**PLANNING AND ZONING COMMISSION AGENDA-REGULAR MEETING**  
Monday, March 12, 2018  
Ketchum City Hall  
480 East Avenue North, Ketchum, ID 83340

**STAFF REPORT**  
**KETCHUM PLANNING AND ZONING COMMISSION**  
**REGULAR MEETING OF MARCH 12<sup>th</sup>, 2018**

**PROJECT:** Stott Residence

**REQUEST:** Mountain Overlay Design Review

Sheet No. **L2.0**  
3

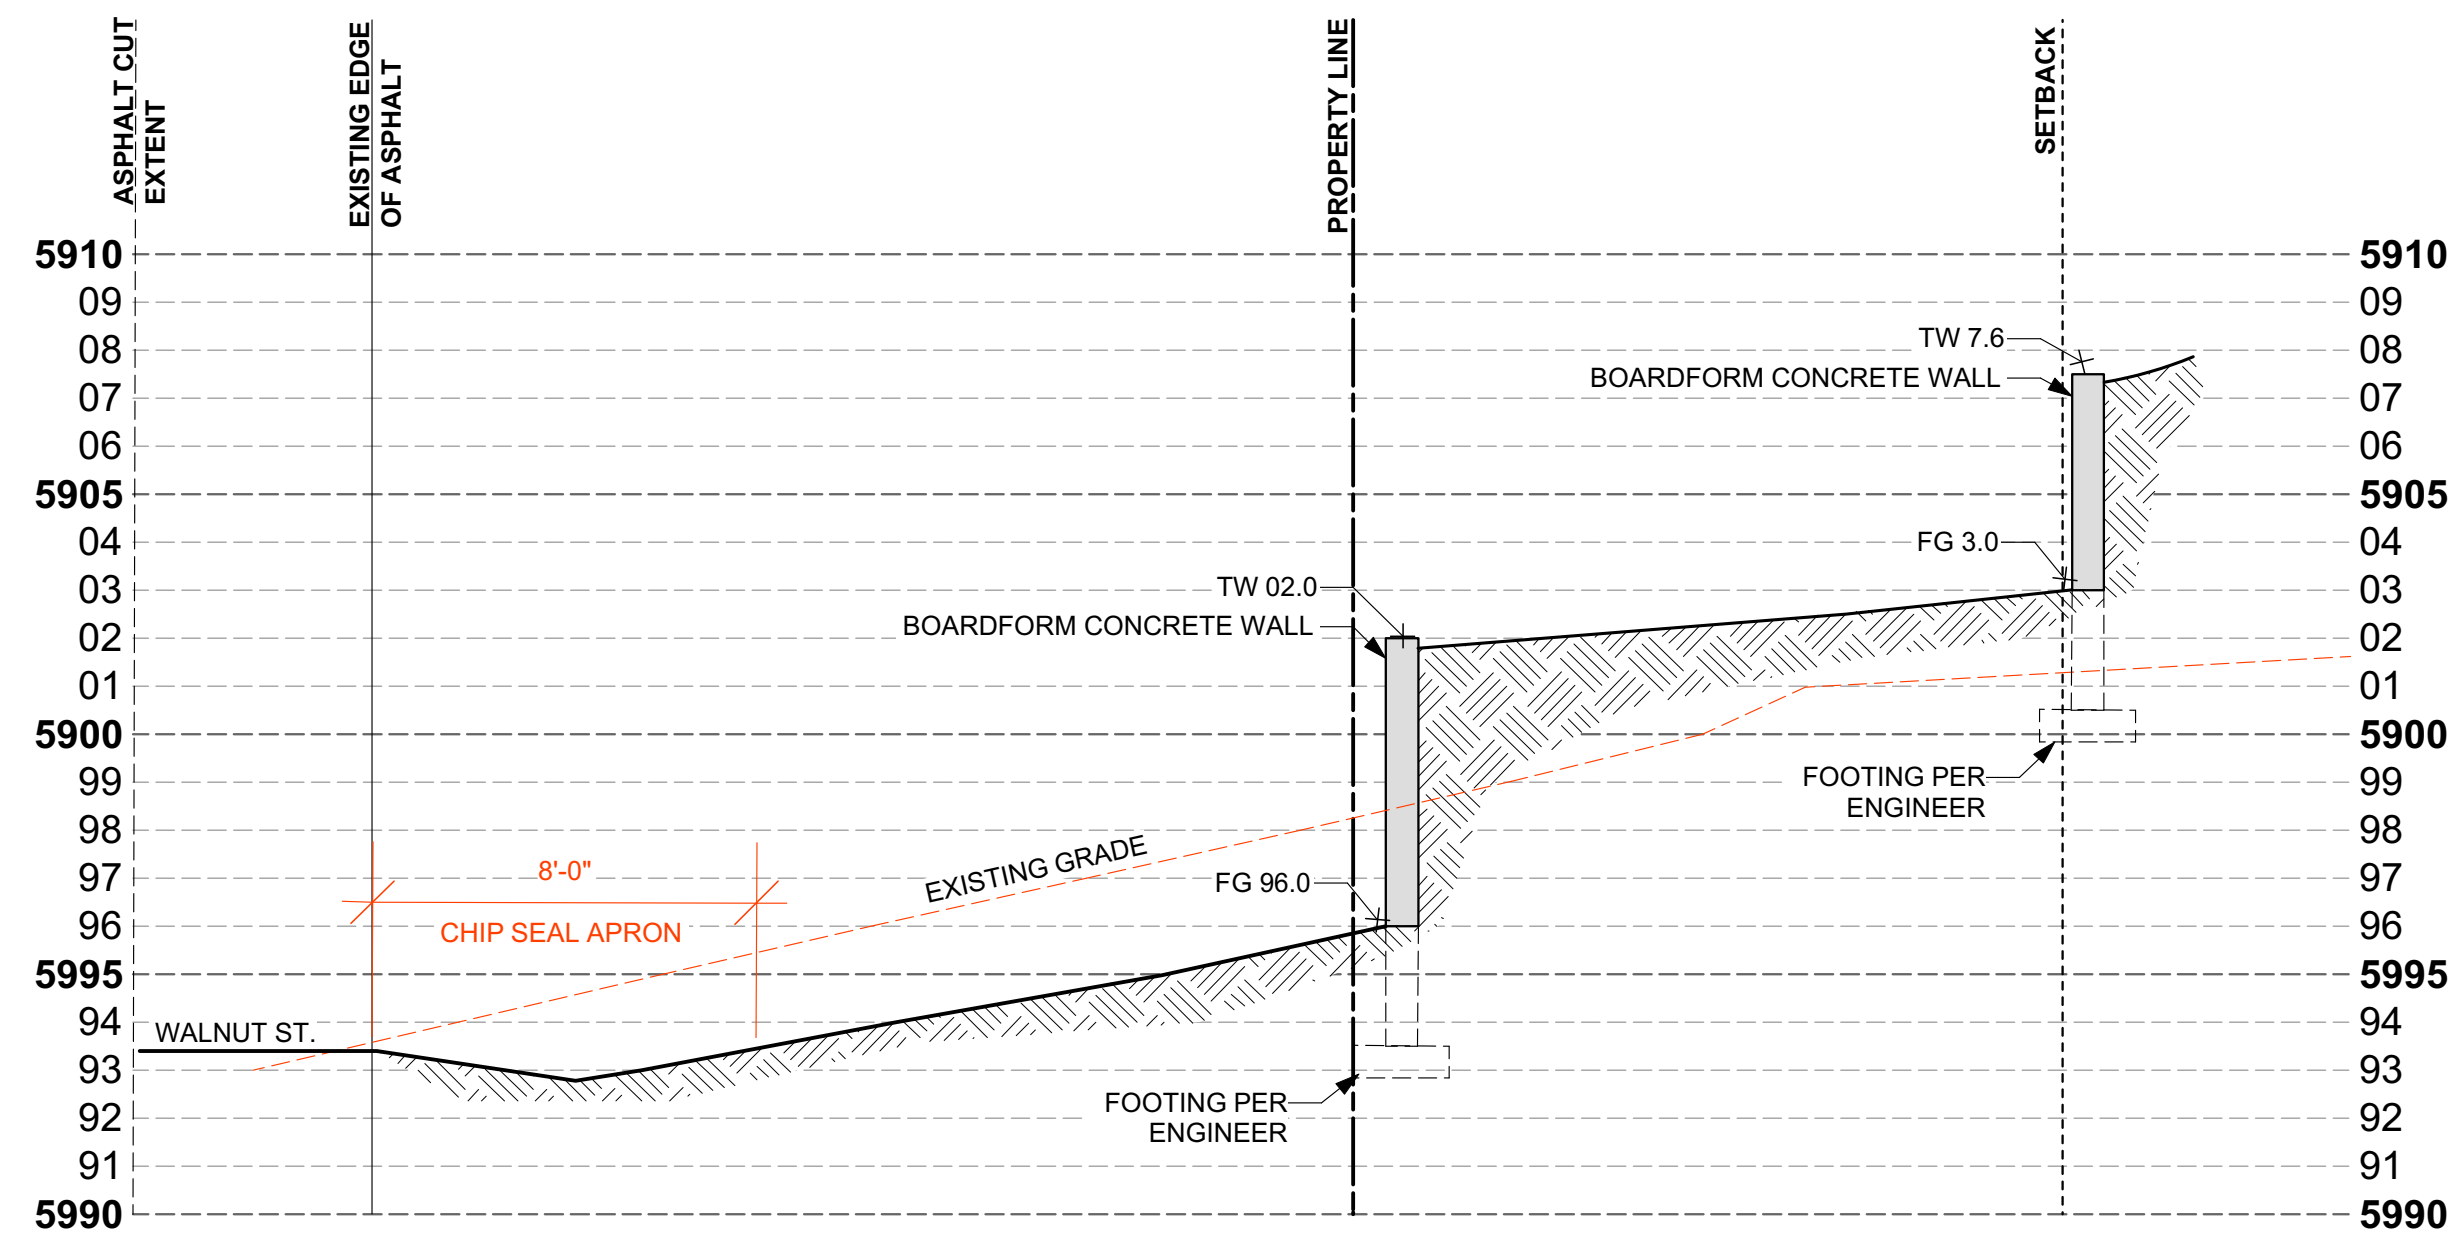
- The proposed trees sited within the Walnut Avenue right-of way as indicated on Sheet L2.0 of the Design Review submittal shall be relocated closer to the property line. Final location of the proposed trees shall be approved by the City Arborist prior to issuance of a building permit for the project.
- Steps within the right-of-way are not approved as indicated on Sheets L1.0 and L2.0 of the Design Review submittal. The steps within the right-of-way on 6<sup>th</sup> Street are not permitted as the proposed siting is over an existing water vault. Steps within the right-of-way on Walnut Avenue must be relocated approximately 4 ft closer to the property line. Final step design and placement shall be approved by the Streets Department prior to issuance of a building permit for the project.

8. Final location and species of the proposed trees within the right-of-way as well as an irrigation plan shall be approved by the City Arborist prior to issuance of a building permit;

1 SITE SECTION: WALNUT AVE.  
Scale: 1/4" = 1'-0"

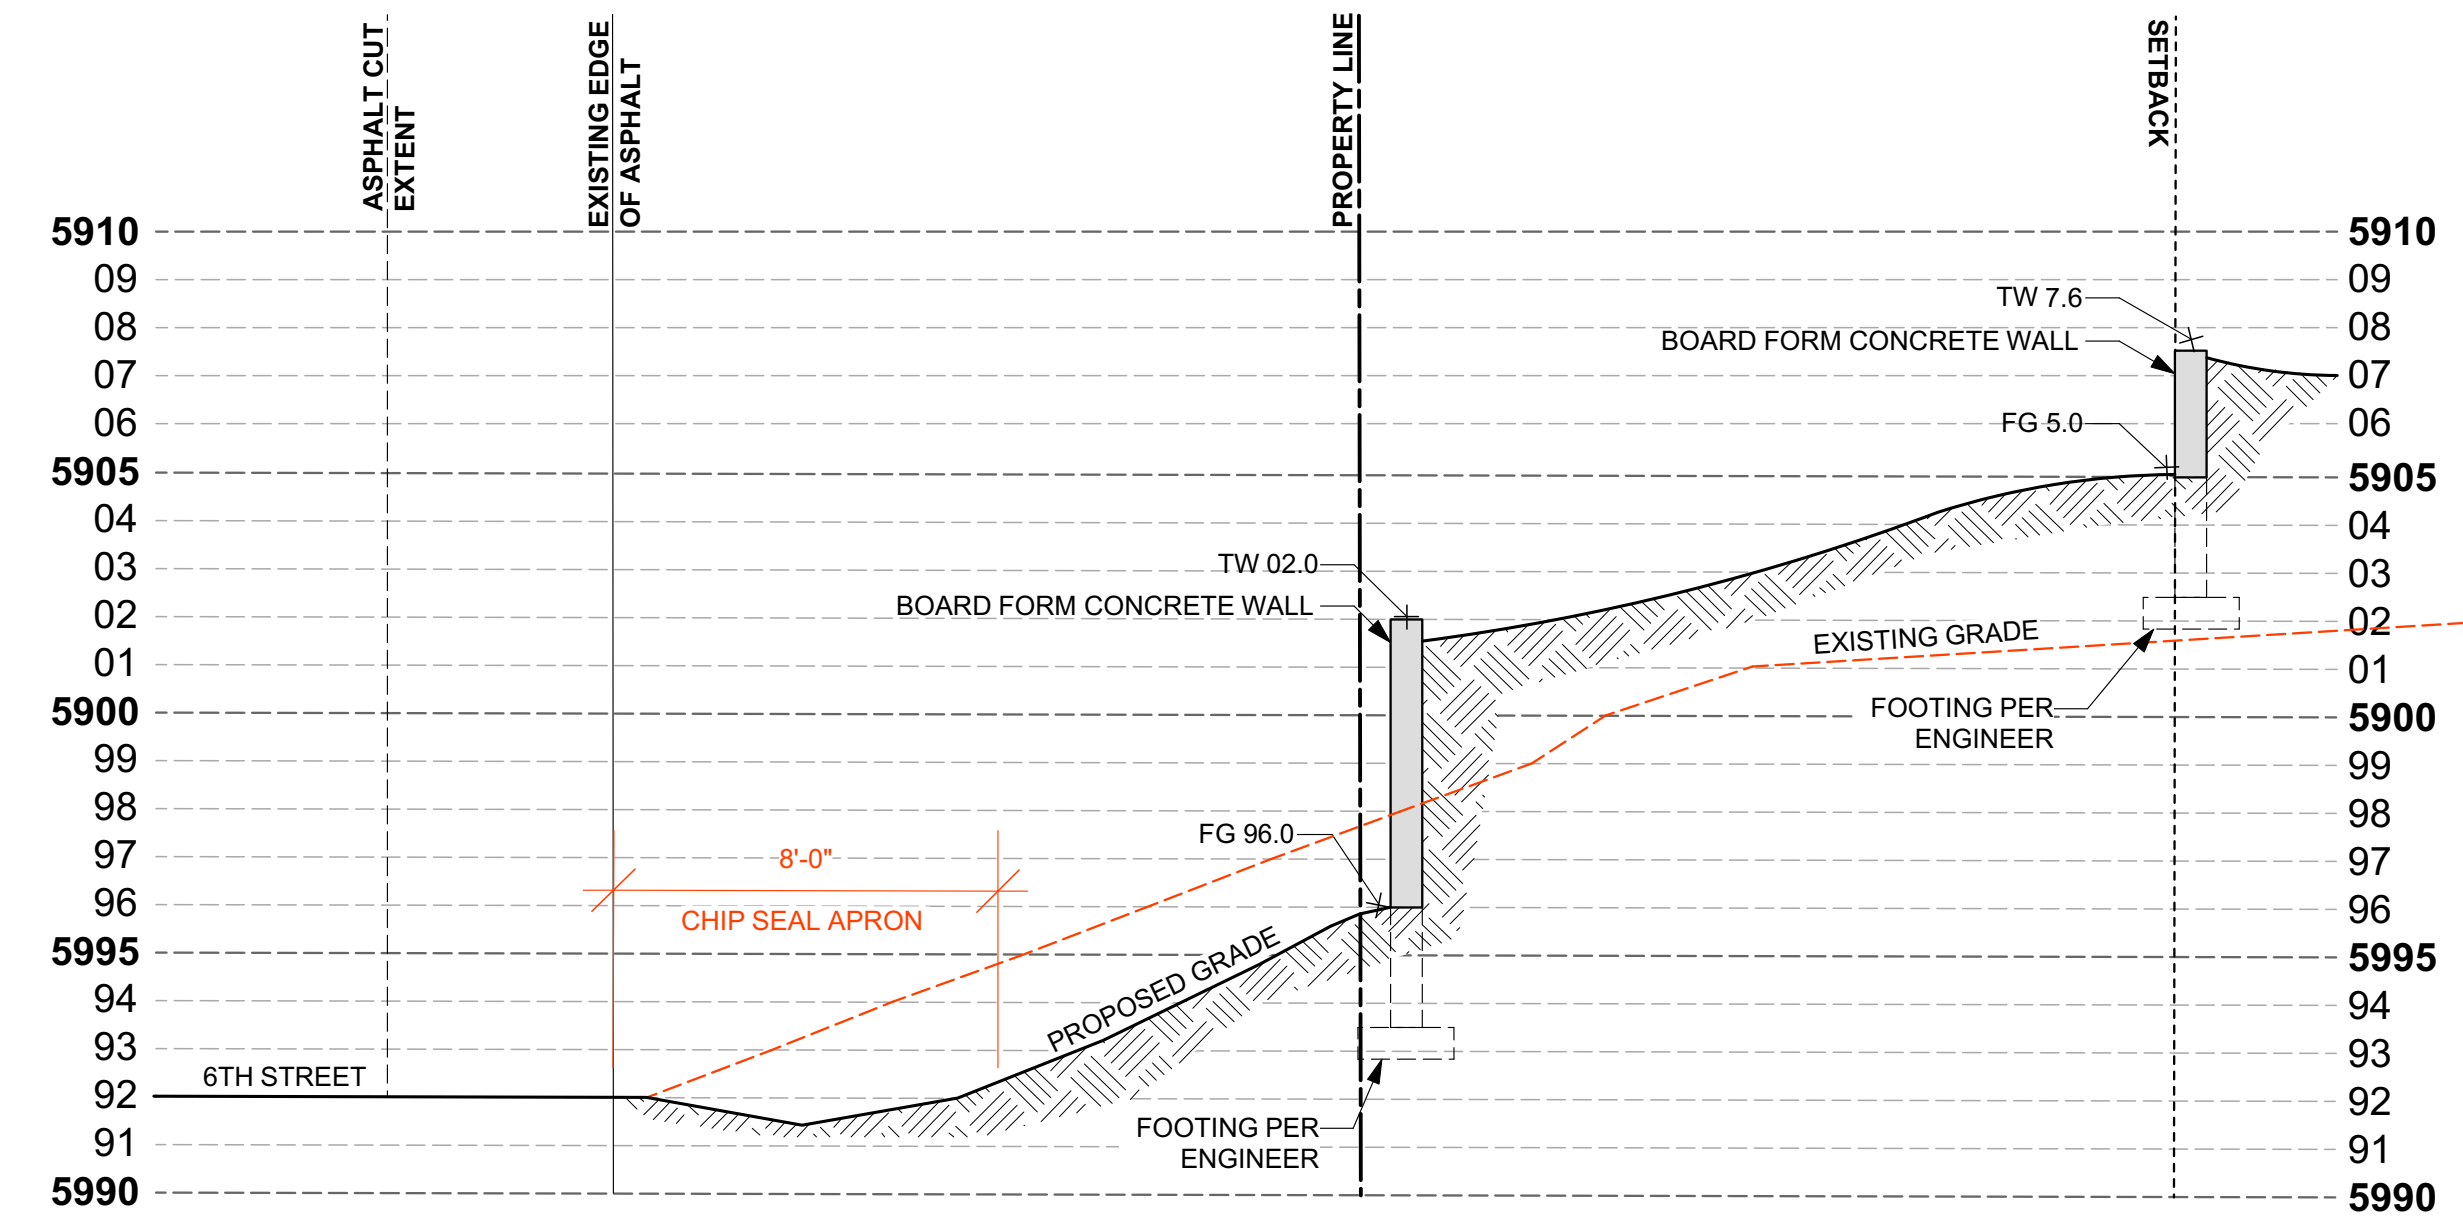
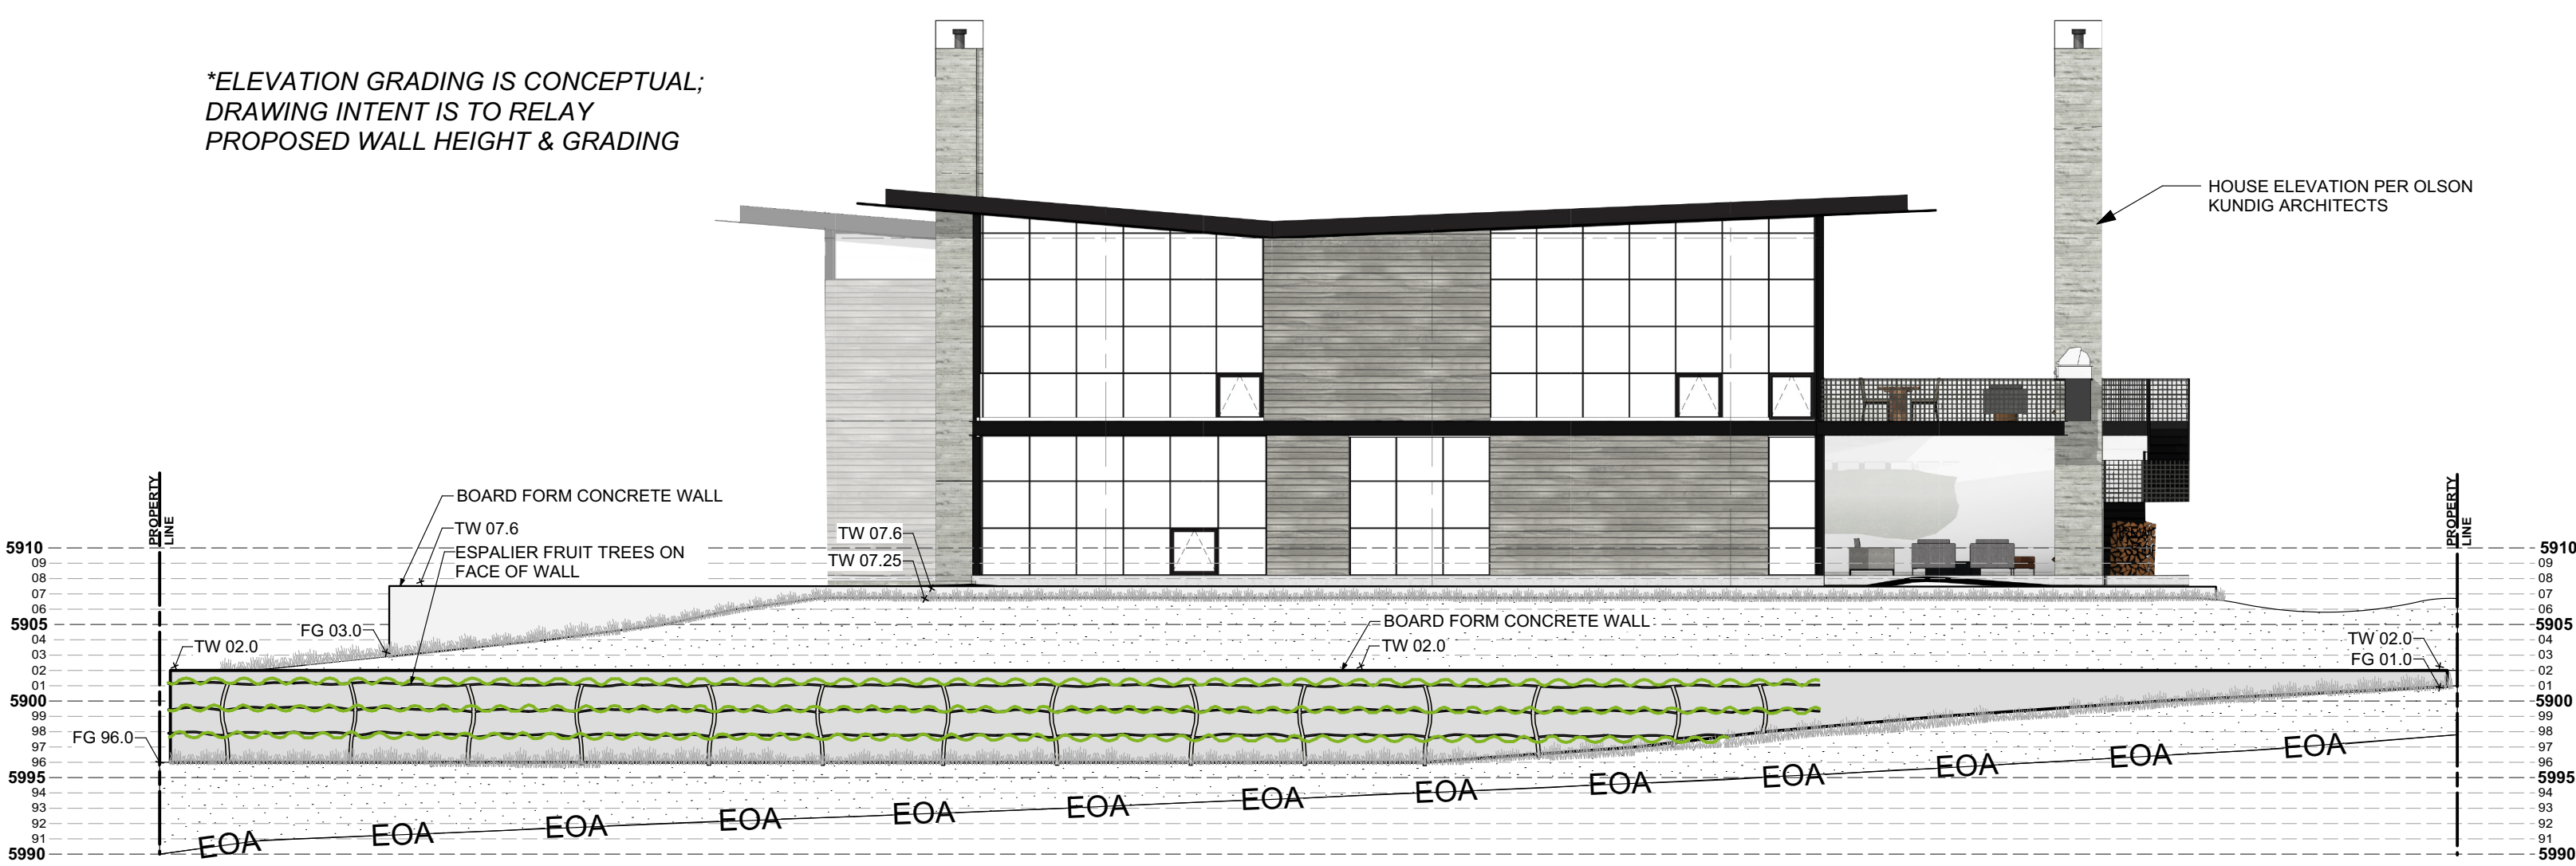
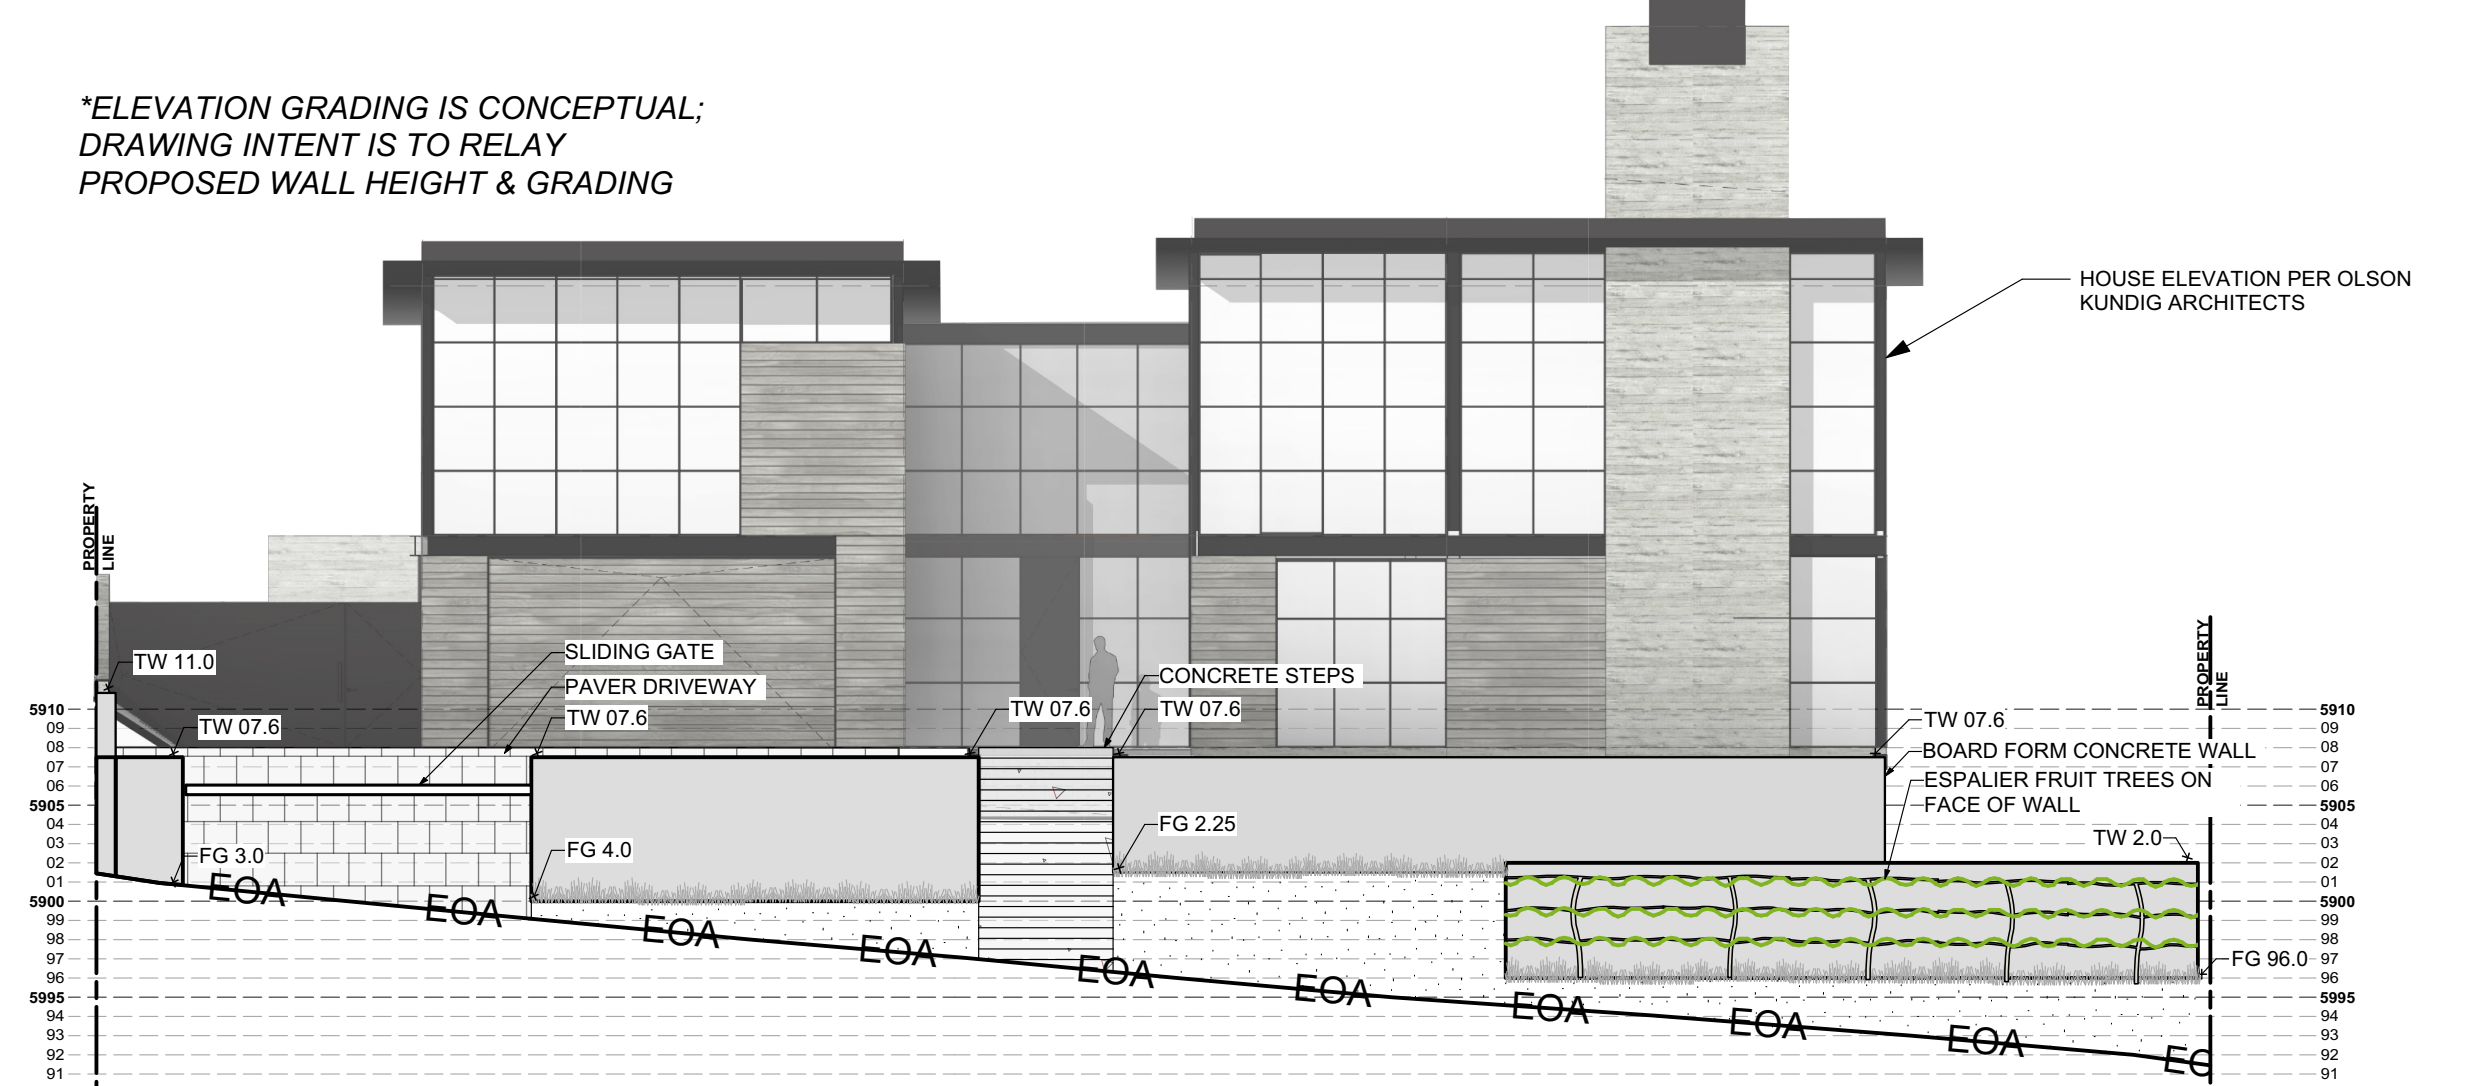
- The applicant provided sections of the proposed right-of-way improvements on Walnut Avenue and 6<sup>th</sup> Street on Sheet L3.0 of the Design Review submittal. Civil drawings for the proposed right-of-way improvements stamped by an Idaho licensed engineer shall be reviewed and approved by the Streets Department prior to issuance of a building permit.

- Sheet L3.0 of the Design Review submittal shows proposed elevations with grading and proposed wall heights. The maximum height of the wall is 6 ft at the corner of Walnut Avenue and 6<sup>th</sup> Street. Ketchum City Code §17.124.130.A requires that walls located less than 30 ft from the front lot line, which is Walnut Avenue, may not exceed 4 ft in height. Walls located more than 30 ft from the front lot line may not exceed 6 ft in height. As the proposed wall retains the site’s sloping grade, the applicant requests that the Planning and Zoning Commission permit the proposed 6 ft wall height. The mass of the wall face is proposed to be softened through the planting of espalier fruit trees.
